FINAL PRODUCT/PROCESS CHANGE NOTIFICATION #20324K-AGeneric Copy

Issue Date: 25-Apr-2014**TITLE:** Assembly and Test site transfer from Kanto Sanyo Semiconductors Co., Ltd to ON Semiconductor SSMP Philippines Corporation (Group 11)**PROPOSED FIRST SHIP DATE:** 01-Sep-2014**AFFECTED CHANGE CATEGORY(S):** Assembly and Test site**FOR ANY QUESTIONS CONCERNING THIS NOTIFICATION:**

MFP30SD → MFP30SDJ

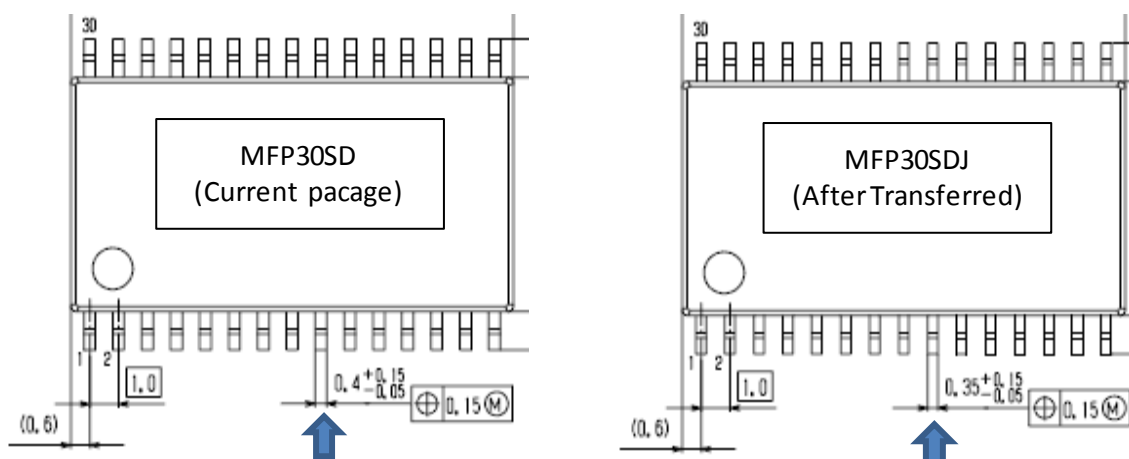
The package will be changed from MFP30SD/MFP36SD to MFP30SDJ/MFP36SDJ which have been manufacturing as standard product in SSMP. This affects for the lead width. In IPCN, it was announced the product name will be changed in accordance with the package change. However, it was decided the product name will NOT be changed finally.

Lead width is changed from 0.40mm to 0.35mm.

MFP36DS → MFP36SDJ

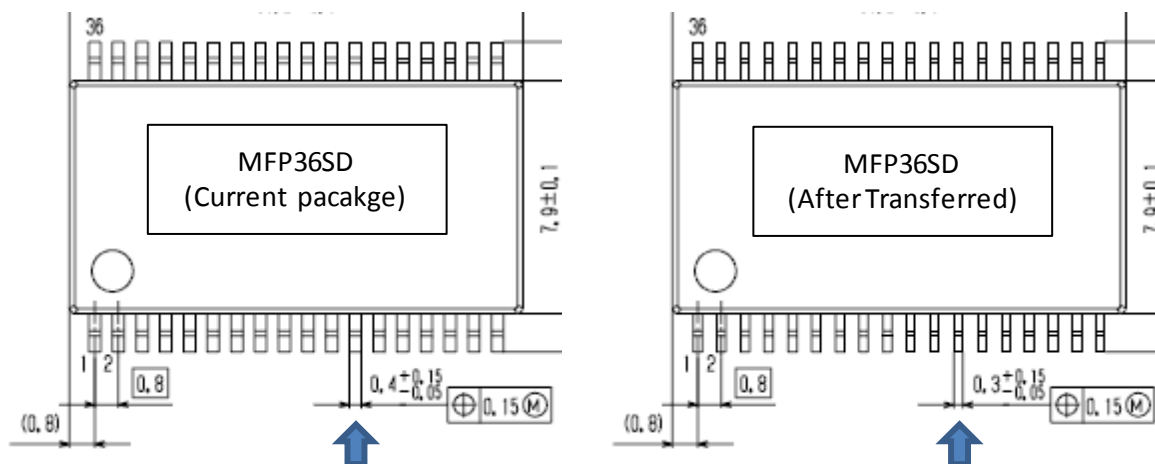
Lead width is changed from 0.40mm to 0.30mm.
